South Shaganappi Study Design Ideas Workshop & CAG Meeting #2

Stakeholder Report Back: What we Heard
May 9, 2016

Design Ideas Workshop

Map 1A

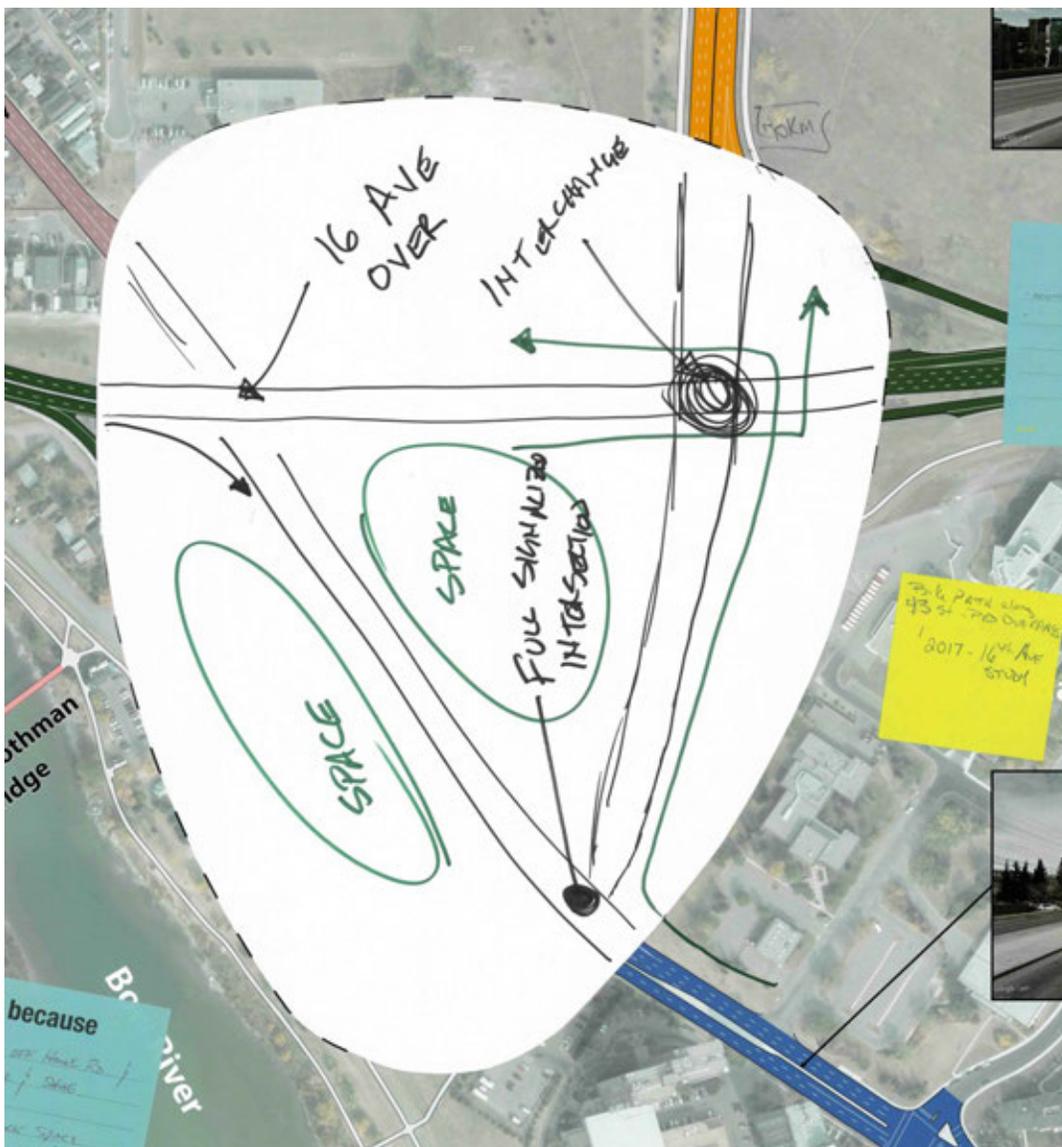
- Concern about the speed transition along 16th Avenue N.W. (80 km/h to 50 km/h to 80 km/h)
- Need for consistent/cohesive speed limits to be integrated into the design

- Better connection from 16th Avenue N.W. to Shaganappi Trail - difficult existing connection
- Integrating safe and effective cycling connections across major interchanges/ intersections

- Safe and effective transition between road classes/speeds (e.g. 16th Avenue N.W. west to Bowness Road)
- Take the pressure off Home Road
- 16th Avenue N.W. & 43rd Street pedestrian/cycling safe crossing (e.g. overpass)

- Preserving a Centre City connection from 16th Avenue N.W. (via Bowness Road/Parkdale Boulevard/Memorial Drive)
- Study on 16th Avenue N.W. not done in advance because it has repercussions

- Different speeds Bowness Road 60 km/h eastbound to 50 km/h westbound, 70 km/h southbound Shaganappi, need for better signage
- #1, 40 Bus Routes – 16th Avenue N.W. to Bowness Road north

- Assumption: 16th Avenue N.W. ramp is mostly eastbound to Memorial Drive traffic
- More space to make left turn east/north to Shaganappi Trail
- Pedestrian/bike overpass at 16th Avenue N.W. & 43rd Street

- Bike path along 43rd Street

- Cleans up intersections Shaganappi Trail to 16th Avenue N.W. west and 16th Avenue N.W. to Shaganappi Trail
- Reduces cut-through traffic opportunities to increase park space and development
- No multi-lane roundabout
- Keep traffic flow off Home Road and move it to 16th Avenue N.W. to Shaganappi Trail
- Cloverleaf
- Provide more park space
- Less traffic on Bowness Road
- Fixes Shaganappi Trail/16th Avenue N.W. issues
- Decrease traffic on Bowness Road or Montgomery and Parkdale/Point McKay
- Additional park space
- Simpler, focused traffic flow
- Increased safety
- Reduced overall interchange footprint
- Avoids multi-lane roundabout

Map 2A

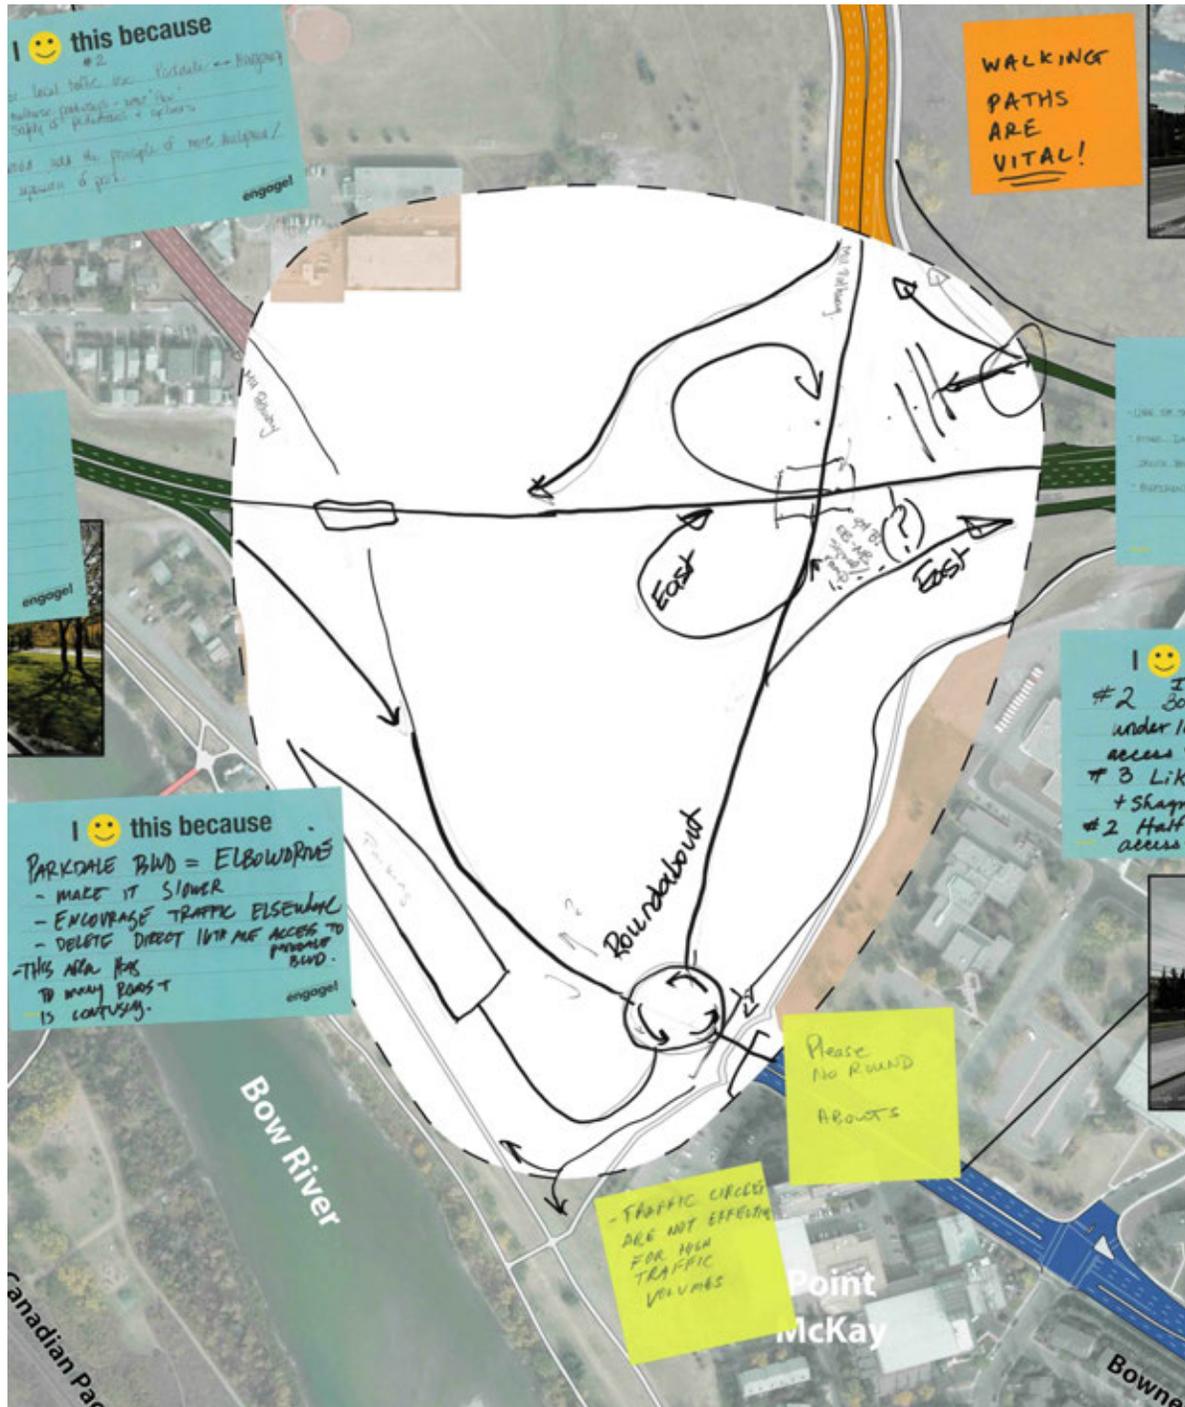
- Concerns about how the area of Shaganappi Trail and 16th Avenue N.W. will impact Bowness Road/Memorial Drive etc.
- Should we be diverting traffic to 16th Avenue N.W. instead of Memorial Drive?

- NO 6 lanes south of 16th Avenue N.W. to manage traffic
- Want safe pedestrian/cycle access from Shaganappi to Bow River pathways
- Better pedestrian access to cross Shaganappi Trail north of 16th Avenue N.W. (or closer to 16th Avenue N.W.)

- Prefer interchange at Shaganappi Trail and 16th Avenue N.W. to make a better east/west movement
- Create underpass for Bowness Road under 16th Avenue N.W. (no more interchange)

- Interchange from eastbound 16th Avenue N.W. to southbound Shaganappi Trail – current operation dangerous
- Roundabout suggested at Shaganappi Trail and Bowness Road because too many signals in area already

- Pedestrian overpasses preferred to connect people from north of 16th Avenue N.W. to Bow River pathways
- Ensuring that communities don't become cut-throughs by making 16th Avenue N.W. more attractive to use

- Make it safer, easier, more attractive to use multi-use pathways

- Better, safer pedestrian crossing overpass? 16th Avenue N.W. and 43rd Street
- Please no roundabouts
- Traffic circles are not effective for high traffic volumes
- Walking paths are vital
- Move main connectors interchange
- Free flow on 16th Avenue N.W.
- Cars can slow down
- Moved parking
- Increased park space

- Keeps Montgomery and Parkdale safe with less traffic
- Puts Shaganappi onto 16th Avenue N.W. as the two major highways
- Good pedestrian and bike access
- Motorized interchange focused on Shaganappi Trail/Hwy 1
- Reduce shortcut via Bowness Road
- Reduce traffic lights
- Make appropriate use of roundabouts
- Pedestrian/multi-use/bike access maintained/improved
- Keep 10 Avenue traffic on 16th Avenue N.W.
- Fixes Shaganappi Trail/16th Avenue N.W. issues
- Decreases traffic on Bowness Road on Montgomery and Parkdale/Point McKay
- Do not like traffic circles
- Flow through traffic
- Parkdale Boulevard = Elbow Drive
- Make it slower
- Encourage traffic elsewhere
- Delete direct 16th Avenue N.W. access to Parkdale Boulevard
- This area has too many roads and is confusing
- Use of traffic circle at Shaganappi Trail and Bowness Road

- Fixes dangerous left hand turn from 16th Avenue N.W. to southbound Shaganappi Trail
- Preferential use of 16th Avenue N.W. vs Bowness Road
- I like Bowness Road continues under 16th Avenue N.W. but no access from 16th Avenue N.W.
- Like lights at 16th Avenue N.W. and Shaganappi Trail
- Half circles direct access from 16th Avenue N.W. and Shaganappi Trail

Map 5A

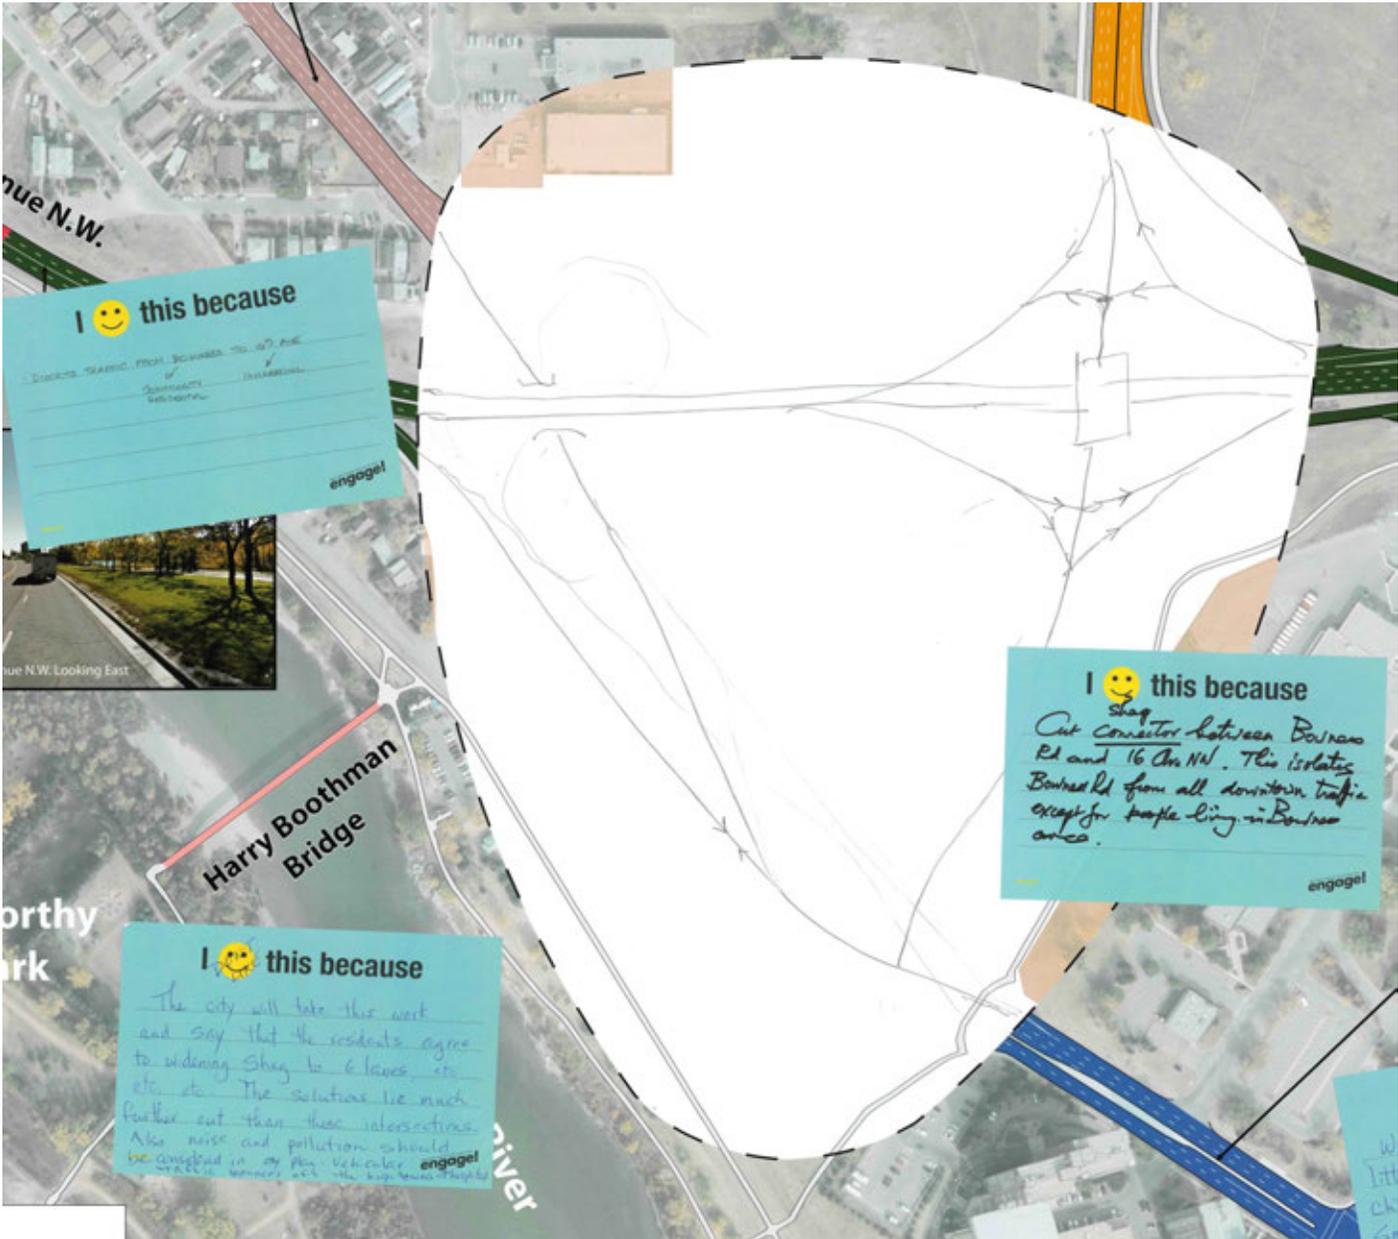
- Separate Bowness Road from the other three major roads
- Improve safety at Shaganappi Trail & 16th Avenue N.W. ramps
- Access to Riverside Club – improve it

- Improve Bowness Road and 37th Street intersection (left turns in AM back up traffic)
- Ban left turns at 37th Street in AM
- Potential advanced left turn arrow at 37th Street and Bowness Road and at 29th Street

- o Improve Edworthy Parking lot – Bigger; Paved; More parking; Potential parking ; Restrictions so people don't park all day; Charge for parking?
- Free flow traffic on Bowness Road for commuters

- Six lane interchange at Shaganappi Trail & 16th Avenue N.W.
- Want Shaganappi Trail to connect to 16th Avenue N.W.
- Need traffic signals to assist pedestrians travelling in area and deter increase of traffic in area

- How will north Shaganappi Trail divert traffic away from this area?
- Don't want Bowness Road to be primary route to downtown, decrease vehicle volume

- How to go from 6 lanes to 3-4 lanes on Shaganappi Trail
- 16th Avenue N.W. bridge at Bowness Road was just rehabbed, don't waste money replacing in near future
- Safety of residents
- Don't want increase of cut-through traffic in Parkdale
- How do we safely connect all the major roads?
- People travelling through the area to the mountains
- Interchanges might be too close together
- Bowness Road is congested in PM
- Noise from increased traffic
- Need to provide accessible pedestrian infrastructure for those who walk in community
- Try to minimize impact on environment
- Minimize landscaping done – keep area as natural as possible is important
- Underground springs may have negative impact on any roadway that's built

- Needs to solve further back
- Concerns about traffic circle
- Why not improve transit by having little shuttle buses from LRT to Children's, Foothills, etc., Much smarter use of our money

- It prioritizes traffic flow to 16th Avenue N.W. and moves the largest interchange northwards
- Diverts traffic from Bowness Road to 16th Avenue N.W. (community residential - commercial)
- The major movement is condensed to one intersection
- It keeps south of 16th Avenue N.W. as small road and not six lanes
- Fixes 16th Avenue N.W. and Shaganappi Trail connector issues
- Calms Bowness Road
- Cut Shaganappi Trail connector between Bowness Road and 16th Avenue N.W. This isolates Bowness Road from all downtown traffic except for people living in Bowness area
- It redirects traffic onto the existing major arterials that need revamping anyway. Also it enhances and increases park area

- The city will take this work and say that the residents agree to widening Shaganappi Trail to six lanes, etc. The solutions lie much further out than these intersections. Also noise and pollution should be considered in any plan. Vehicular traffic bounces off the high towers at hospital

Map 6A

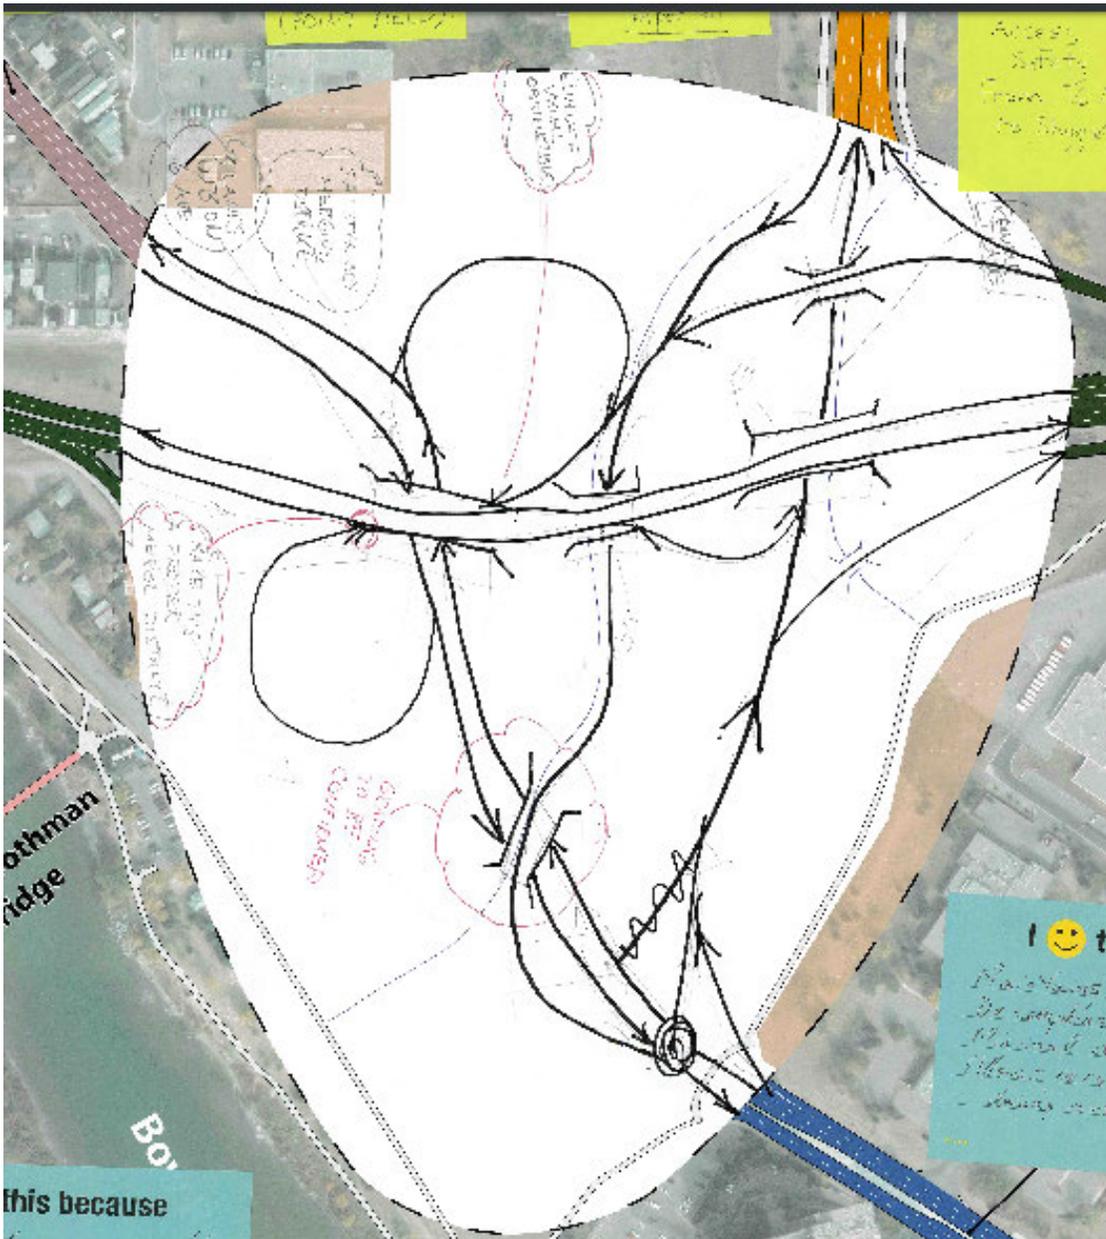
- 37th Street and Glenmore Trail
 - o Don't create something similar
 - o Don't like and dangerous
- No merge from Bowness Road to 16th Avenue N.W.
 - o Would like access from Shaganappi Trail to 16th Avenue N.W.

- Shaganappi Trail is an overflow from Crowchild Trail - concerned about 6 lanes north being narrowed down by Memorial Drive
- Don't necessarily need to connect Shaganappi Trail to Bowness Road

- Bowness Road to Shaganappi Trail northbound is an important movement
- Bike path to hospital is a nightmare
- Southbound Shaganappi Trail to Bowness Road do not need access eastbound. All traffic onto 16th Avenue N.W. Traffic eastbound on 16th Avenue N.W. can then connect over Bowness Road

- Left turn lane intersection at Shaganappi Trail southbound and 16th Avenue N.W. gone – everyone in group agrees
- 16th Avenue N.W. should be the primary road, not Bowness Road

- A lot of bikers park in Edworthy
- Need to elevate intersection so it's free flow from 16th Avenue N.W. to Shaganappi Trail
- We want to keep the connection between Bowness Road and 16th Avenue N.W.

- G rails cause visual obstruction
- Need easy way from Shaganappi Trail to northbound 16th Avenue N.W. – unsafe so people take side roads
- Loops are a yield and need to be merge

- Access from Bowness Road to 16th Avenue N.W. Eliminate loop ramp, create larger loop to allow for merge and access to Shaganappi Trail
- Eliminate lights at Bowness Road and Shaganappi Trail

- Bow River pathway up to university – how do they get across Bow? – Under Bow
- Bowness Road alignment is good for servicing Montgomery
- Need arrow signal onto 29th Street

- Westbound Bowness Road traffic is too heavy, need left turning lane on 37th Street
- Eastbound Bowness Road to 16th Avenue N.W. eastbound – keep the off ramp

- Hard to get safely out of the co-op without using side streets

- Desire for free flow from 16th Avenue N.W. eastbound to Shaganappi Trail northbound
- Important to have merge lanes
- Left turn light to get on to 37th Street
- 37th Street and Glenmore Trail - don't like this idea
- Safety/speeding on Bowness Road
- Access from Bowness Road WE to 16th Avenue N.W. WB improved (point yield)
- Shaganappi Trail southbound to 16th Avenue N.W. westbound important
- Concern: traffic on six lanes on Shaganappi Trail
- 29th Street - needs a left turn signal
- Access safety from 16th Avenue N.W. to Shaganappi Trail
- Dislike traffic signals on Bowness Road
- Doesn't do enough to calm Bowness Road

- Separates with minimal construction impact and allows for six lane plan
- This plan eases traffic congestion and adds safety to vehicle and pedestrian traffic flow
- It is a safer design by changing yields to merges and minimizes traffic lights
- Bike paths have been accounted for
- Smooth traffic flow
- It limits implication on traffic construction
- Utilizes fair amount of existing infrastructure
- Discourages use/access of Bowness Road for non-residents/non-local traffic
- No additional traffic lights (slows traffic)
- Best assessment to handle six lanes of traffic volume
- Only small changes
- Flow on safety
- Constructability
- Keeps traffic flowing without stoplights
- Well thought out intersections and bicycle/pedestrian paths

- Good flow and discourages use of Bowness Road
- No roundabouts!
- Eliminate current problem areas such as westbound TCH to southbound Shaganappi Trail
- Fixes Shaganappi Trail /16th Avenue N.W. issue
- Focus on traffic flow
- Maintains same traffic flow
- De-emphasizes Bowness Road
- Minimal disruption
- Allows rerouting traffic during construction phasing

Map 1P

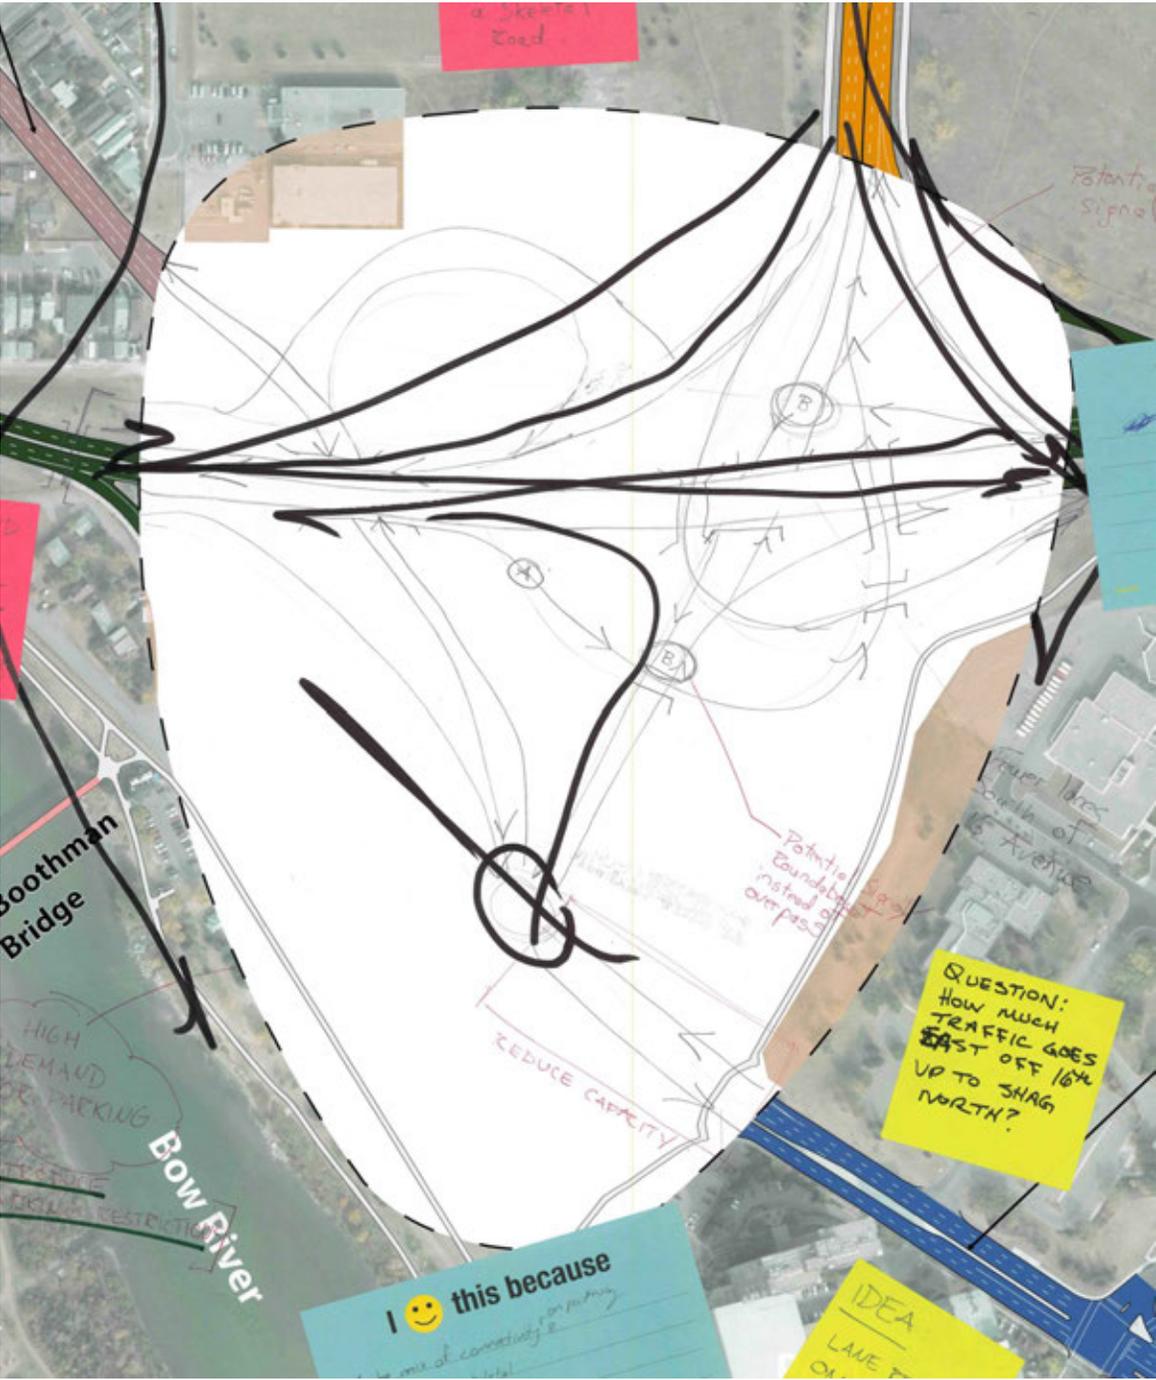
- 16th Avenue N.W. does not operate like a skeletal road currently
- Make 16th Avenue N.W. a viable option to go west to Centre City
- Connect Shaganappi Trail and 16th Avenue N.W.
- Consider fly-overs instead of clover leafs
- Maintain a connection to Market Mall from Point McKay
- Consider lane reversal along Bowness Road/ Parkdale Boulevard/ Memorial Drive
- Create free flow connection between 16th Avenue N.W. and Shaganappi Trail
- Maintain movement even if it's slower so that users feel like they are getting to where they're going
- Explore all options including multi-level interchanges
- Create multi-use pathway connection to the river and regional pathway
- Potential "Bike n' Ride"
- Limit time of parking along the river

- Ensure we understand broader origin and destination requirements
- 16th Avenue N.W. does not seem to operate as a skeletal road
- Desire lane to Sarcee Trail
- Should the traffic flow be improved on 16th Avenue N.W. west?
- Eastbound 16th Avenue N.W. decision point
 - o Memorial Drive/Parkdale Boulevard
 - o 16th Avenue N.W. eastbound
- Use 29th Street to get into Parkdale?
- Important to have Crowchild Trail upgrades
- How much traffic goes east off 16th Avenue N.W. up to Shaganappi Trail north?
- Idea - lane reversal on Bowness Road
- Review parking restrictions in Parkdale
- Desire to maintain the crosswalks

- It fixes connection issues at 16th Avenue N.W. and Shaganappi Trail, calms Bowness Road, addresses parking
- Free flow of commuting traffic northwest to centre/south
- Good traffic flow
- It has good traffic flow
- Like mix of connectivity on pathway
- Free flow on skeletal
